12th adaptation to scientific and technical progress of exemptions 2(c)(ii), 3, 8(e) and 8(g)(ii) of Annex II to Directive 2000/53/EC (ELV)

Final Report

Written by a consortium led by Bio Innovation Service, with the participation of Fraunhofer IZM and UNITAR
Between December 2023 and July 2024

Figure 5-3: Results of machinability assessment of different Copper materials

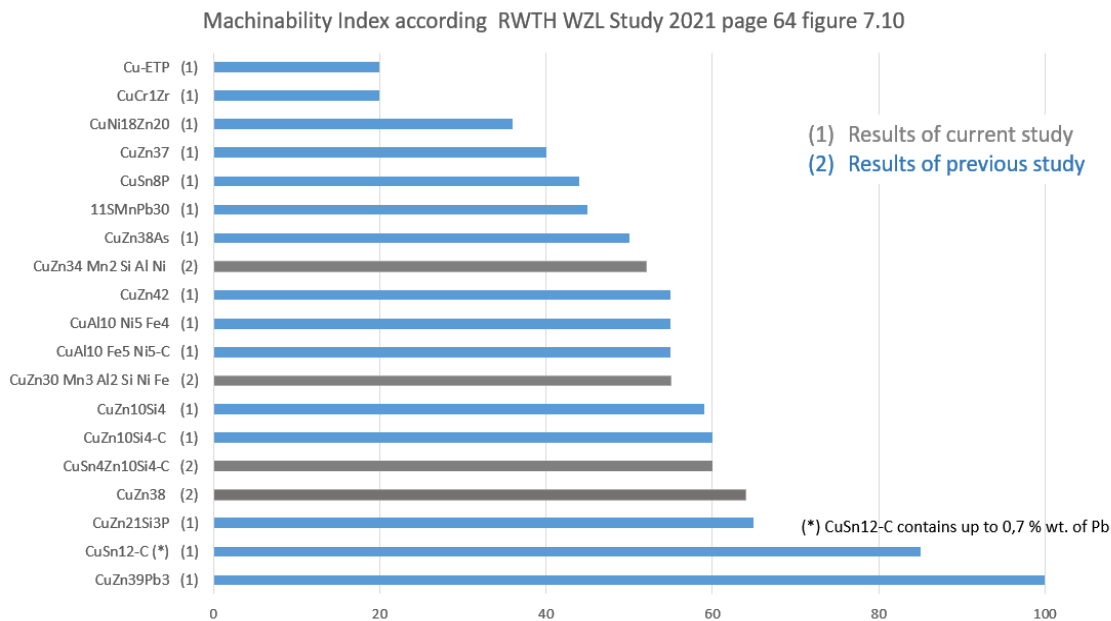
The consultants acknowledge the effort of the copper industry to the set industry guidelines, but point out that out of the presented 19 alloys in Figure 5-3, only 4 are new to the present exemption review, whereas the remainder had already been available during previous revisions of this exemption since the referenced previous study, which was completed in June of 2013 (Lung 2013).

(Wieland 2024b) contributed to the machinability results by RWTH Aachen study (Figure 5-3), but also produced machinability indexes themselves (Table 5-6). For instance, Wieland report a machinability index for CuZn21Si3P (eco SW1 ®) of 90 %, in contrast to the 65 % reported by RWTH Aachen.

Figure 6-2: Screenshot of the current DA5 customer presentation

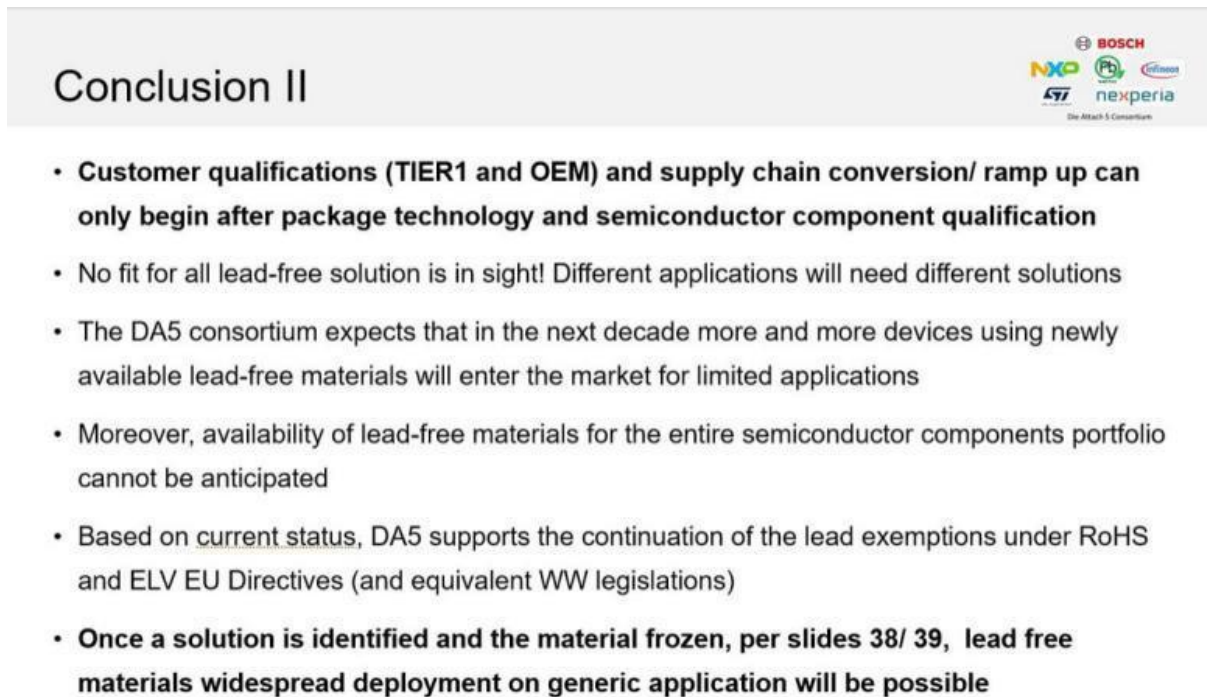
ACEA et al. (2024e) point out that the current status and the progress achieved is periodically reported by the DA-5 consortium. They are pleased to have received from their partners the information that the DA-5 information should be considered in its full context and refer to the Conclusion II of the latest DA5 project customer information displayed in Figure 6-2.

According to ACEA et al. (2024e), the explanation given for that what was meant by “DA5 consortium expects that in the next decade more and more devices using newly available lead-free materials will enter the market for limited applications” is the following: The sentence is only one on the conclusion slide (see above) and is referring to new products. The DA5 never published a roadmap and ACEA et al. can’t publish a roadmap since there is no solution for the conversion of legacy products available.
